**AIA**[®]**Document G701[®] – 2017****Change Order**

PROJECT: *(Name and address)*
 2023-121A Juliet W. Long School - HVAC
 Project
 1854 CT-12
 Gales Ferry (Ledyard), CT 06335

CHANGE ORDER INFORMATION:
 Change Order Number: 002
 Date: 09-30-2025

Electrical Changes per Bulletin #1r1 for splitting panels by north/ south wings.

PROJECT:
ENGINEER:
DESCRIPTION: Steel Louvered Filter Grille
530FF-1-1///18.000/18.000/SM/F//0/0/L/HT/QTR-TURN/1/B12

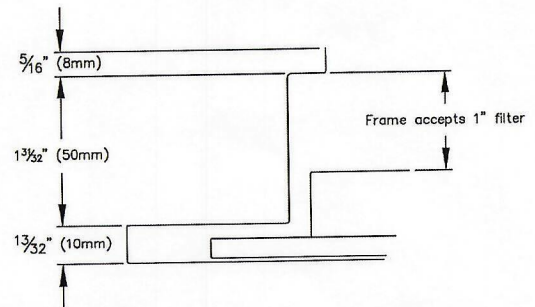
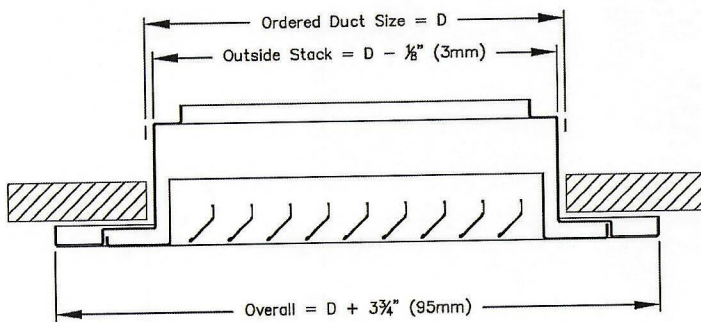
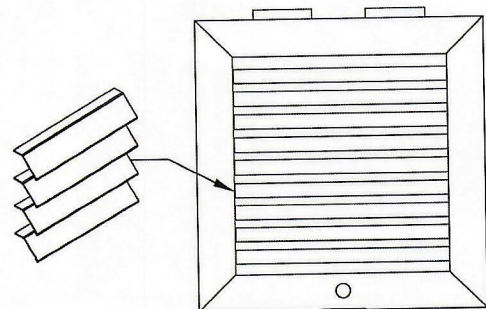
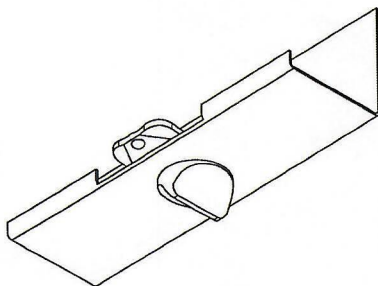
Below please find material and labor pricing to demolition and then fabricate and install new galvanized duct riser which is located in the storage room to allow space for the new electrical work. This work also includes revising the existing duct work below the riser in the crawl space and installing two new 18" x 18" filter grilles on the existing duct in the crawl space.

Includes Galvanized Steel Duct and Accessories and
Filter Grilles (See attached submittal for the basement grilles)

PARTIAL FLOOR PLAN
FLOOR INFILL AT
CUST.28

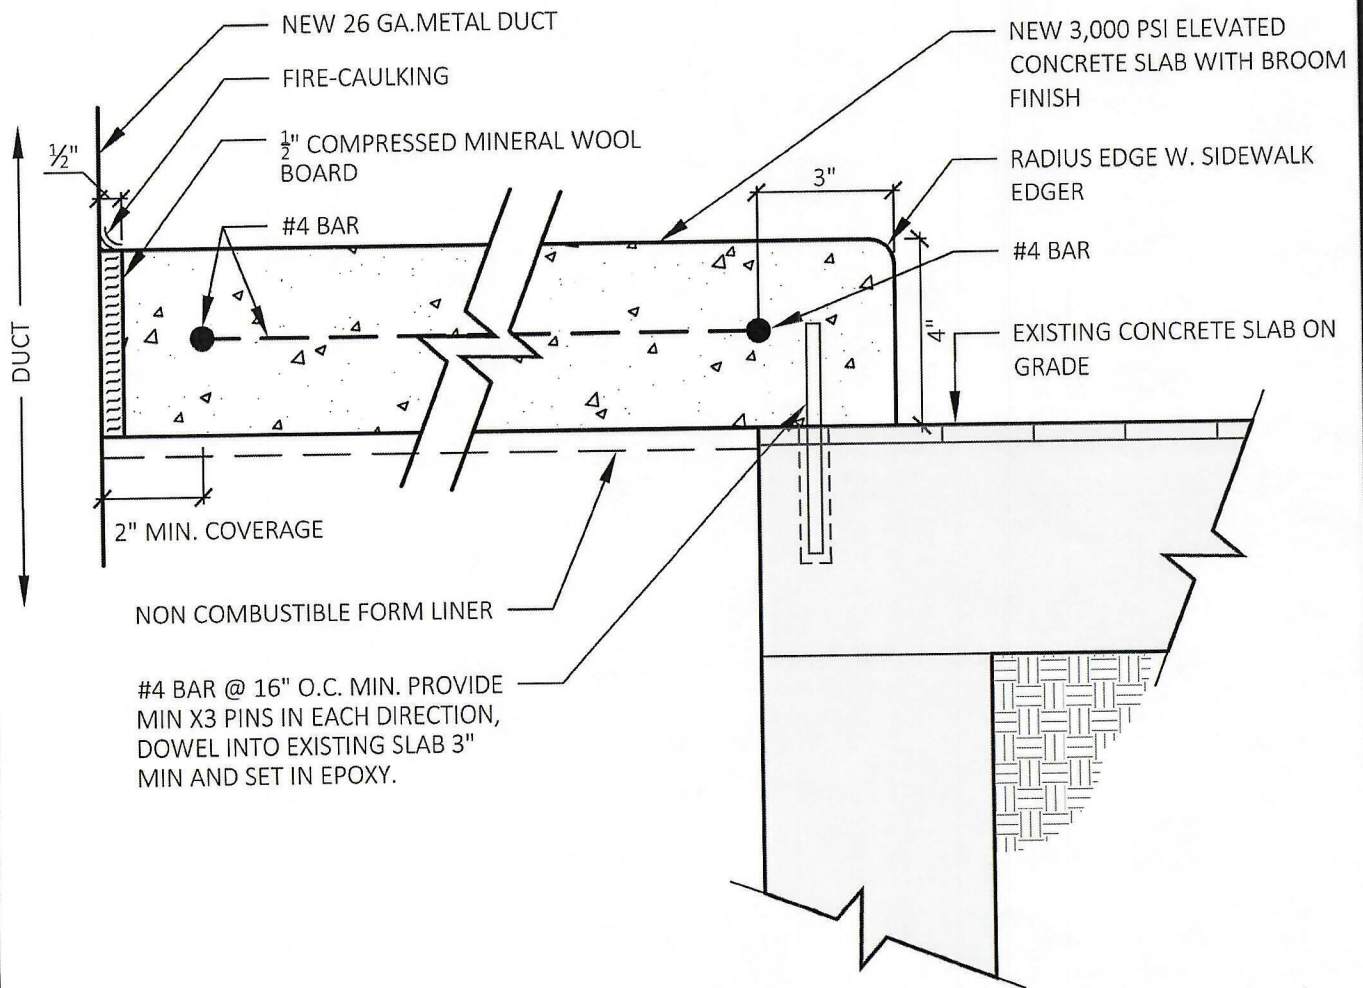
CONCRETE CURB INFILL:

- PROVIDE NEW 4" TALL CURB AND ELEVATED SLAB
- 3000 PSI CONCRETE
- #4 REINFORCING BAR
- BROOM FINISH ON TOP OF SLAB/INFILL

NEW CONDUIT SEAL, W/ FIRE CAULK

PIN TO WALL W/ #4 BAR, EPOXIES IN.

SEAL ALL SIDES W/ FIRE CAULK, SEE SKA-03

NEW 26 GA DUCT V.I.F.
